Informal document **GRE-77-21**
(77th GRE, 4-7 April 2017,
agenda item 7 (b))

**Task Force
on Electro-magnetic Compatibility
(TF EMC)**

Status report of TF to GRE-77
Tuesday, 4. April 2017

(Change of the R10-05 narrow band limit consistent with CISPR 12)

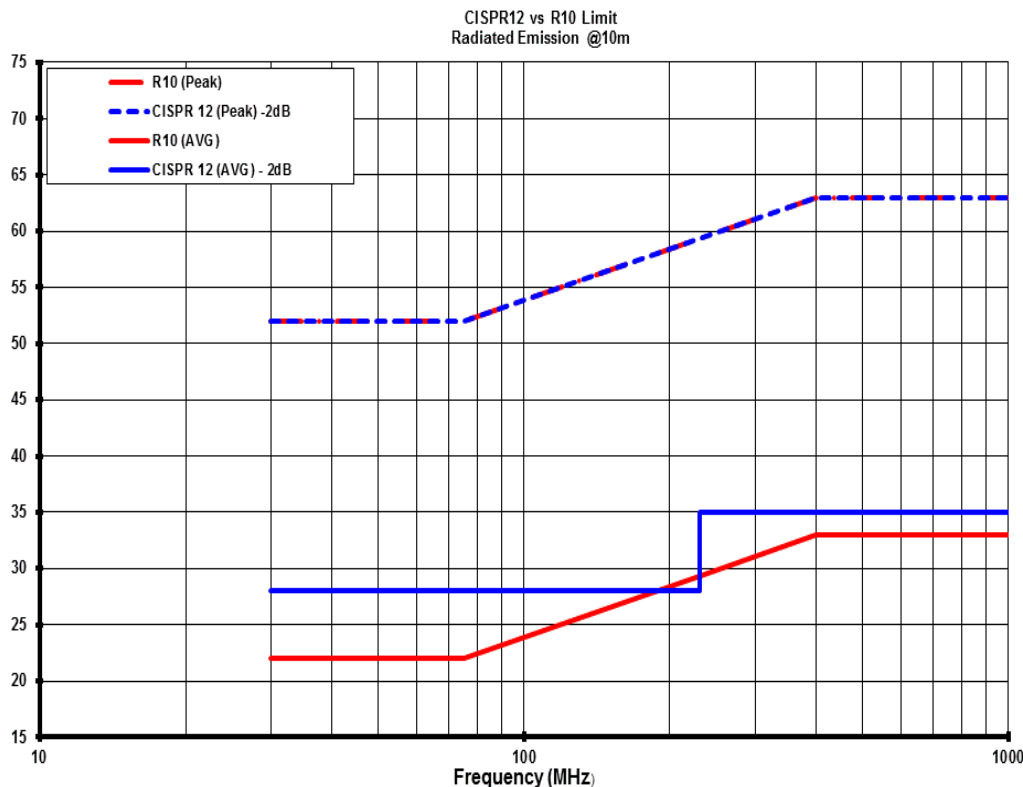
- It has been precised that in order to get a R10-05 vehicle narrowband emission limit consistent with the CISPR 12 vehicle narrowband limit, the **new R10.05 limit should** be the CISPR12-limit minus 2dB to take into consideration this 2dB more stringent requirement as defined in CISPR 12 for type approval.

For information:
This figure shows also the consistence between the R10-05 and CISPR12 broadband peak limits.

The proposal for new R10-05 narrowband limit is shown in blue, in comparison to the present R10-05 narrowband limit in red.
